# PROPERTY CONDITION REPORT

## ADA TIER III SURVEY

Report for: Joey Stewart, Smokey Bones Bar and Fire Grill

Project Number: ADA062121SmokeyBonesUticaMI

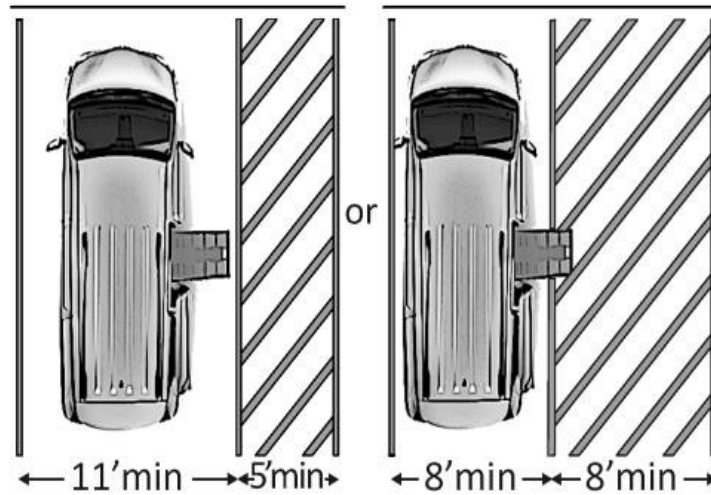
**Item 1. Discrepancies at the five ADA accessible parking spaces include poor striping/marketing for the parking spaces and access aisles, the access aisles do not have adequate width, the narrow aisles do not connect directly to an accessible route, depressions with excessive slopes and trapped standing water, cracks with excessive openings in the surface of the parking spaces and access aisles, no vertical signage to**

**identify the parking spaces, no wheel stops at any of the parking spaces near the exterior walkways.** The photo above shows the poor striping/marketing at one of the access aisles. All of these five accessible parking spaces and the access aisles have this discrepancy. In fact the entire parking lot has poor striping/marketing and significant damage to the surface. Part of the parking lot was blocked by the installation of a temporary tent shelter.

Implementation regulation 28 CFR Part 35.133, Maintenance of Accessible Features, state, “A public entity shall maintain in operable working condition those features of facilities and equipment that are required to be readily accessible to and usable by persons with disabilities by the [ADA] Act or this part”. In other words, the damaged parking lot surface should be repaired and the striping/markings should be re-applied.

The two larger access aisles and the two smaller access aisles are too narrow in width. The larger access aisles should be at least 8 feet wide because the adjacent van-accessible parking spaces are slightly wider than 8 feet. The narrow access aisles should be at least 5 feet in width. The photo on the left shows one of the narrow access aisles.

**RECOMMENDATION:** Re-design and resurface the existing accessible parking surfaces and access aisles to comply with the Standards. The parking spaces and access aisles should not have any slope exceeding 1:48, or 2.08%, in any direction. Repair the cracks and openings in the surface of the parking lot. Ensure that all access aisles adjoin an accessible route. Install vertical signage for each accessible parking space. Install wheel stops where parking spaces are adjacent to exterior accessible routes.

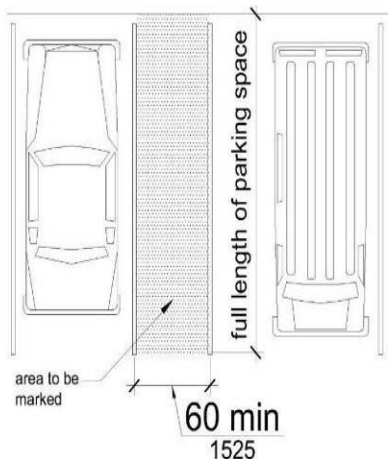
The narrow access aisles do not adjoin an accessible route. The forward end of these access aisles join to the side of a walkway, but there is no curb cut to accommodate the elevation of the walkway. The photo on the right is representative.

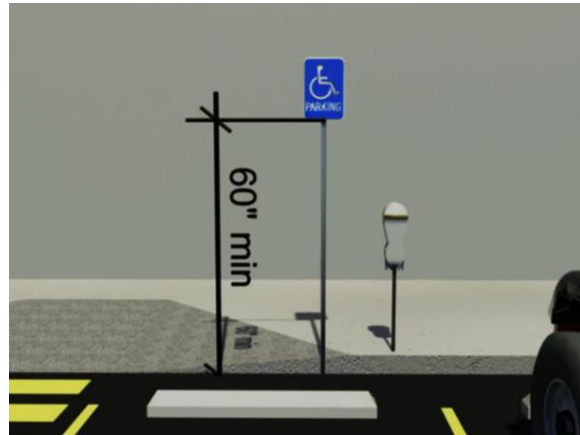
Depressions in the asphalt surface of the parking spaces were observed holding standing water and the slope of the depressions exceeds 1:48. The photo below is representative of these depressions that appear to be caused by the weight of parked vehicles.

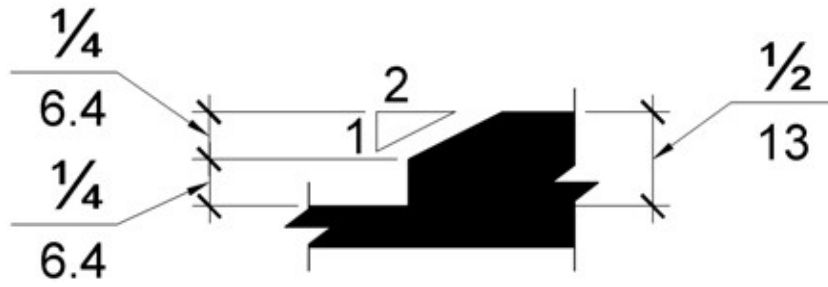
**Item 2. The exterior walking route from the municipal bus stop to the front entry at the facility has excessive cross slope on the east side of the facility and there is a large gap and excessive change of elevation where the walkway approaches the front patio area. See the photo on the right for the excessive cross slope. Along this portion of the route the cross slope is approximately 2.9 – 4.8%.**

The photo on the right is where the walkway shown above approaches the front patio area at the main entrance. There is a gap between the walkway and patio and an abrupt change in elevation that exceeds ½ inch in some areas.

RECOMMENDATION: Alter or replace this section of walkway so the cross slope does not exceed 1:48 and the connection to the patio is smooth.

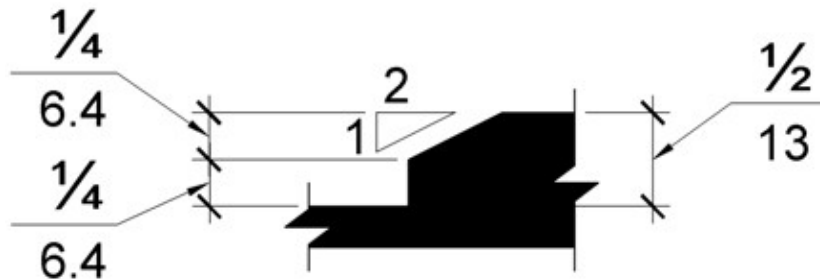
**Item 3. The walkway to the north side auxiliary exterior pedestrian entry/exit door is run sloped excessively, there is a gap where the sections of the sloped walkway meet, and there is an excessive abrupt change of elevation where the short sloped walkway meets the adjacent longer east-west walkway. See the photo on the right.**

The photo on the left shows the gap between the two sections of the walkway (yellow arrow) and the excessive abrupt change of vertical elevation (red arrow). The excessive abrupt change of vertical elevation is a significant tripping hazard.

This short walkway appears to have settled relative to the adjacent longer east-west walkway. This settlement has created the excessive run slope of 9%, the gap, and the excessive abrupt change of elevation. The total change of elevation along this walkway is approximately 7.5 inches. If this walkway is not going to be rebuilt, it should be considered a ramp and should have handrails on both sides because the total change of elevation exceeds 6 inches.

**RECOMMENDATION:** Rebuild this sloped walking surface to comply with the 2010 ADA Standards for either a walkway or ramp. Eliminate the gap between the two sections and the abrupt excessive change of vertical elevation at the adjacent east-west walkway. See Exterior Doors below for related comments about the exterior maneuvering space for this door.

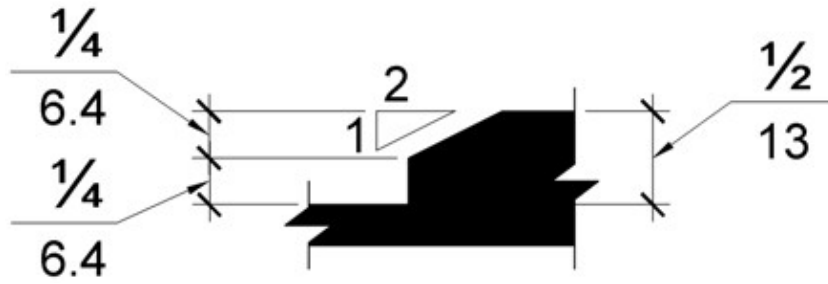
**Item 5. The exterior patio at the front/main entrance to the facility has openings between sections that are filled with dirt and gravel, and some of these openings have excessive abrupt changes of elevation. The photo on the right shows the patio.**

The photo on the left is a closeup example of these openings. This is a tripping hazard.

The photo on the right is another example of an opening and tripping hazard.

**RECOMMENDATION:** Consider rebuilding the entire patio surface or repairing the openings to create a patio walking surface that is stable, firm, slip resistant, and level with no excessive abrupt changes of elevation.

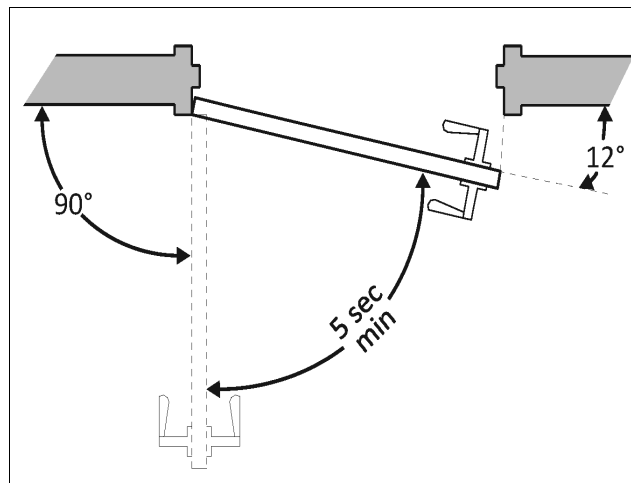
**Item 7. All four doors in the east entry/exit installation close automatically but the left exterior door and both interior doors close too quickly. The single secondary door on the north side also closed too quickly.** These doors closed to a position of 12 degrees from the latch in less than 5 seconds. The photo on the right shows the two interior doors at the primary entrance vestibule.

**RECOMMENDATION:** These door closers should be adjusted, repaired or replaced, as applicable. The east side emergency exit door should be disarmed and tested for compliance with closing rate.

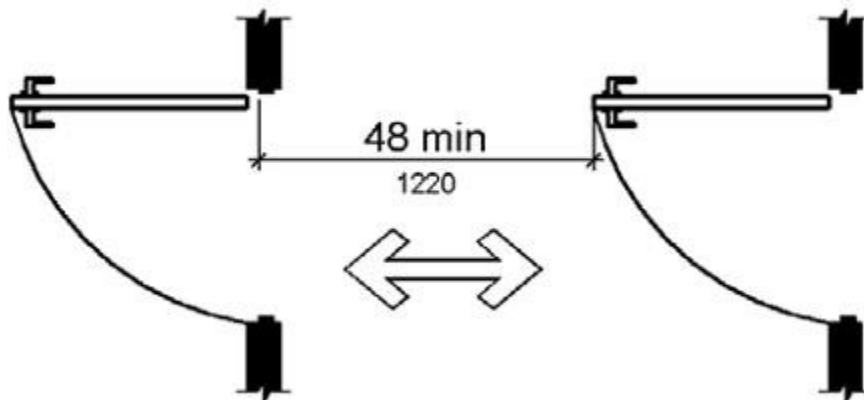
**Item 8. The spacing between the two interior doors and the two exterior doors for the primary entrance vestibule are installed too close together for doors installed in a series. See the photo on the right.**

2010 ADA Standard 404.2.6, [Doors, Doorways, and Gates] Doors in Series and Gates in Series, states, "The distance between two hinged or pivoted doors in series and gates in series shall be 48 inches (1220 mm) minimum plus the width of doors or gates swinging into the space." See the graphic below for a representation of this Standard applied to this installation. In the photo above the distance between the open door and the closed door is approximately 20 inches.

**RECOMMENDATION:** Redesign and re-install the interior doors for this vestibule entrance, or abandon the vestibule installation and remove the interior doors.

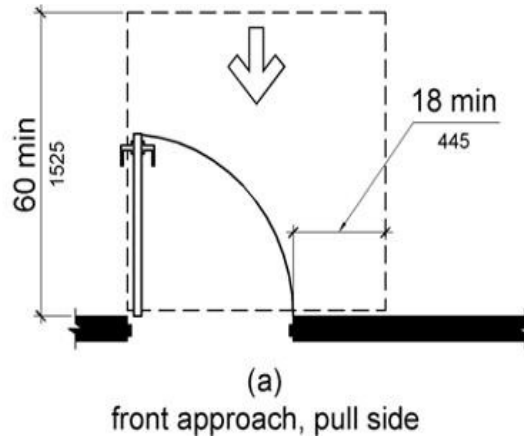
**Item 9. Two of the exterior single door entrances have door handles on the outside and could be used as temporary or alternative entry doors into the facility. If this is the case going forward, the door maneuvering spaces at the exterior of these doors should be accessible, and they are not presently. The north side single door also drags on the threshold and the frame at the latch when operated. The photo on the right shows the north door.**

2010 ADA Standard 404.2.4.4, [Doors, Doorways, and Gates] Floor or Ground Surface, states, "Floor or ground surface within required [door] maneuvering clearances shall comply with [Standard] 302. Changes in level are not permitted. EXCEPTION: 1. Slopes not steeper than 1:48 [2.08%] shall be permitted." In other words the door maneuvering space should be mostly level. The run slopes of the maneuvering spaces for these doors are 2.8% for the east side door and approximately 9% for the north side door.

At both door installations the maneuvering space parallel to the door on the latch side is approximately 12 inches, which is not wide enough. The photo on the left is representative.

The photo on the left is where the north side door drags on the threshold. This makes the door difficult to open.

**RECOMMENDATION:** Alter the exterior door maneuvering space for these two exterior doors to provide level surfaces and adequate accessible door maneuvering space. Repair the north side single door so it does not drag on the threshold or the frame at the latch when operated.

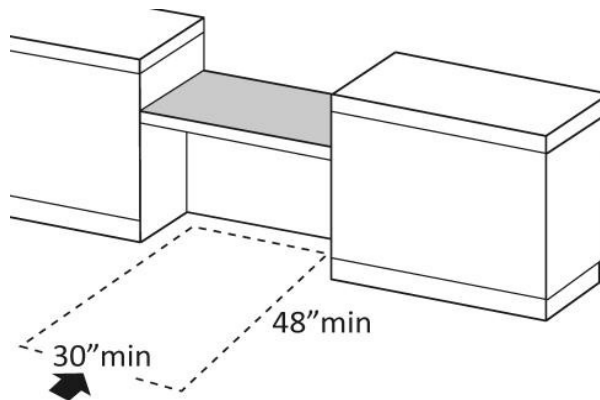
**Item 12. The counter for the bar is consistently 41.5 inches above the finished floor. None of the bar height is accessible for disabled individuals.** See the photo on the right.

**RECOMMENDATION:** Alter the bar counter to provide at least 5 percent of the seating spaces and standing spaces at the bar with an accessible forward approach to an accessible portion of the counter as per Standard 902.

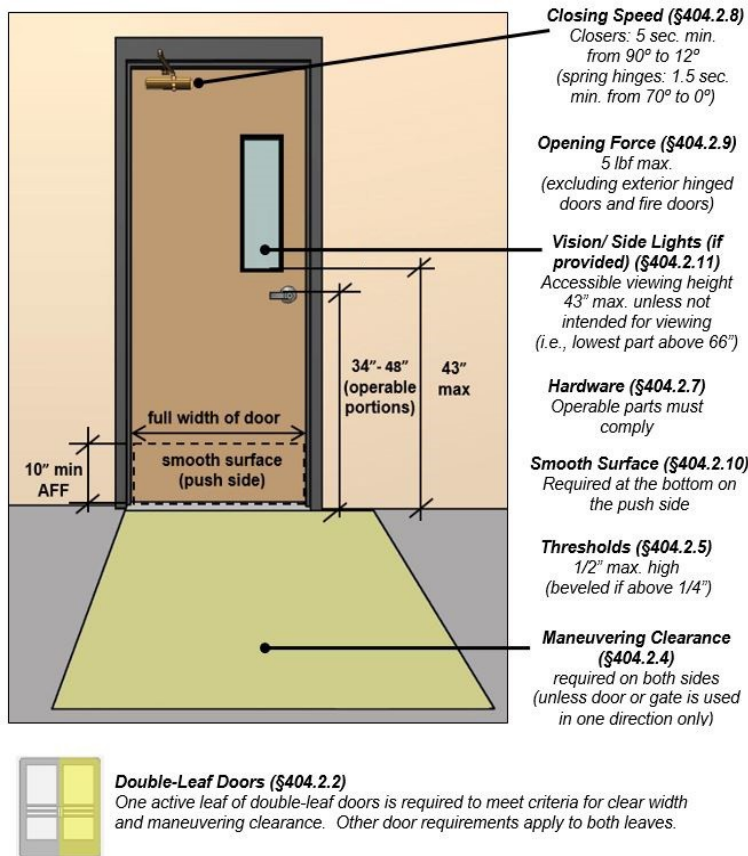
**Item 13. This is a three level facility. There are steps and an elevator that provide access to all three levels. The elevator was not operational at the time of this inspection, probably because the electrical power was disconnected to the facility. See the photo on the right. Note that the elevator was used to store other components.**

**RECOMMENDATION:** Remove the stored items from the elevator, have power restored to the facility, and have the elevator evaluated for design and operation in accordance with the ADA Standards.

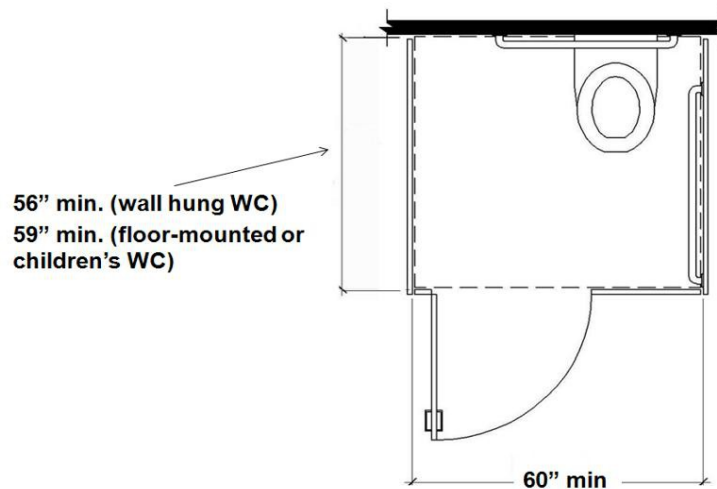
**Item 17. The partitions in these employee toilet rooms limit the stall space at the toilets to only approximately 36 inches in width. This is inadequate space for an accessible toilet stall [compartment] and for wheelchair transfer clearance at the toilet. The photo on the right is representative. The toilet is behind the partition.**

**RECOMMENDATION:** Consider ways to increase the wheelchair transfer space in these toilet rooms, or convert the two toilet rooms to one compliant unisex toilet room. The graphic below is a representative floor plan with a wheelchair transfer clearance at the toilet and a clear space at the sink. Note that the sink clear space is allowed to overlap the toilet wheelchair transfer space.

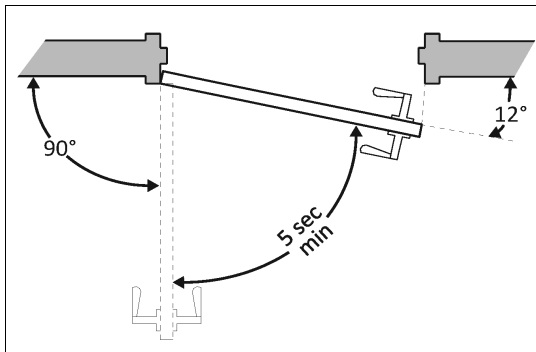
**Item 19. Both employee toilet room entry/exit doors have automated closers that allow the doors to close too quickly and both doors require excessive force to open.** The photo on the right shows the two doors.

Both entry doors required approximately 8 pounds of force to open. Standard 404.2.9, Door and Gate Opening Force, states, "The force for pushing or pulling open a door or gate other than fire doors shall be as follows: 1. Interior hinged doors and gates: 5 pounds maximum."

**RECOMMENDATION:** These door closers should be adjusted, repaired or replaced.

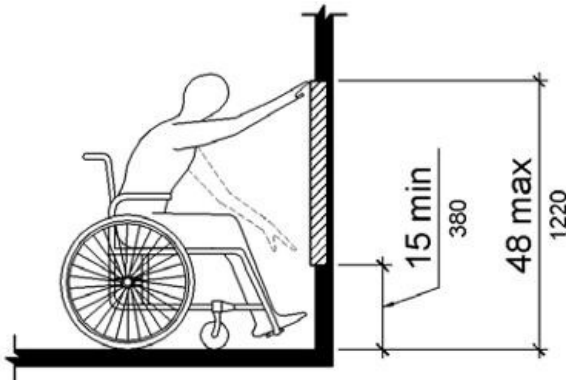
**Item 21. In both employee toilet rooms the paper towel dispensers are installed too high above the finished floor and so as to create a protruding object in the circulation path.** The photo on the right is representative. These dispensers are more than 27 inches above the finished floor and project more than 4 inches into the circulation path.

**RECOMMENDATION:** Relocate these dispensers so they are not protruding objects, or replace with a model that does not protrude. Lower these installations to within ADA reach ranges.

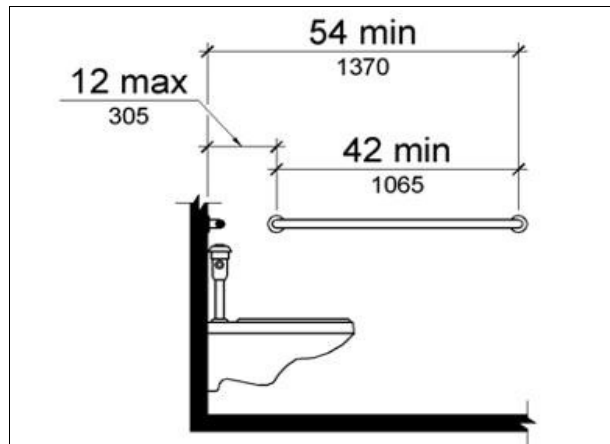
**Item 25. In both employee toilet rooms no grab bars are installed at the toilets.** The photo on the right is representative.

**RECOMMENDATION:** Install the grab bars on the rear and side wall in both employee toilet rooms.

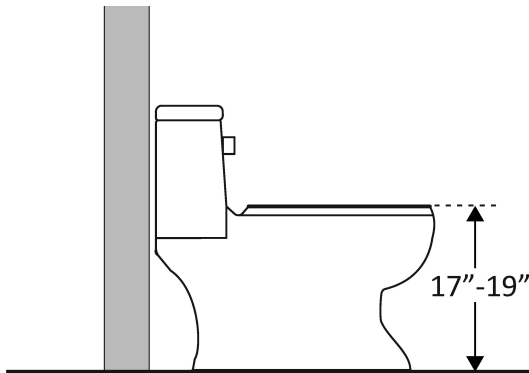
**Item 26. In both employee toilet rooms the toilet seat height is too low to the floor, the toilets are mounted too far from the side wall, the toilet paper dispensers are mounted too close to the toilet, and in the Women's toilet room the toilet flush handle is not on the open side of the toilet. The Men's toilet seat is loosely installed. See the photo on the right for the loose toilet seat in the Men's toilet room.**

Each toilet seat in each toilet room is mounted approximately 15.5 inches above the toilet room floor. 2010 ADA Standard 604.4, [Water Closets and Toilet Compartments] Seats, states, "The seat height of a water closet above the finish floor shall be 17 inches (430 mm) minimum and 19 inches (485 mm) maximum measured to the top of the seat. Seats shall not be sprung to return to a lifted position."

**RECOMMENDATION:** Replace or alter the toilet installations in the both employee toilet rooms to raise the toilet seat height, install the toilets closer to the side wall, relocate the toilet paper dispensers in both toilet rooms and re-install the covers, and alter or replace the toilet in the Women's toilet room to place the flush handle on the open side of the toilet. Repair the Men's toilet seat so it is not loose.

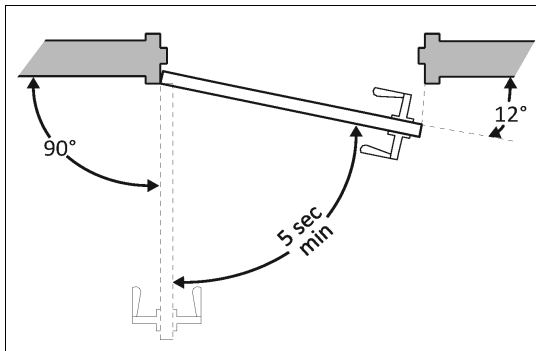
**Item 28. In both public toilet rooms the pedestrian entry/exit doors require excessive force to open and the automatic door closers allow the doors to close too quickly. See the photo on the right.**

Both entry doors required approximately 8 pounds of force to open. Standard 404.2.9, Door and Gate Opening Force, states, "The force for pushing or pulling open a door or gate other than fire doors shall be as follows: 1. Interior hinged doors and gates: 5 pounds maximum."

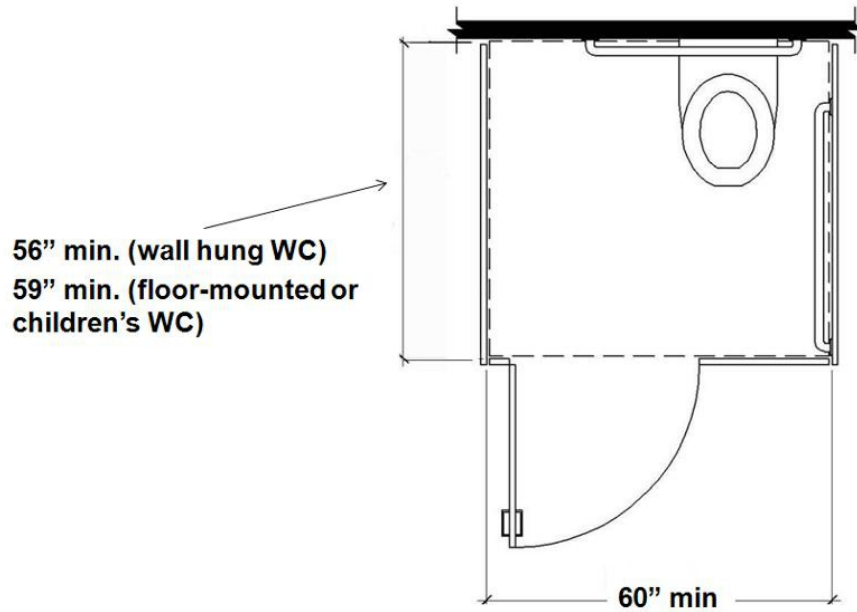
**Item 30. In the Men's public toilet room the rear wall behind the toilet is angled in such a way as to compromise the space required for an accessible toilet compartment (stall) and the space required for wheelchair transfer. See the photo on the right.**

**RECOMMENDATION:** Alter the rear wall in the Men's public toilet room to provide the space required for an accessible toilet compartment (stall) and the space required for wheelchair transfer.

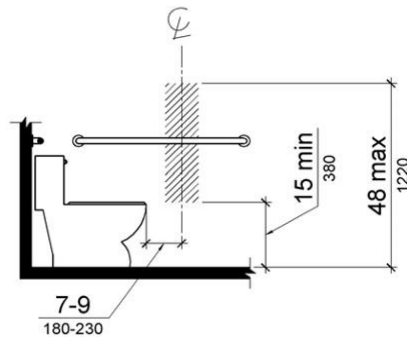
**Item 34. In the Men's public toilet room the toilet paper dispenser is installed too close to the toilet. See the photo on the right.**
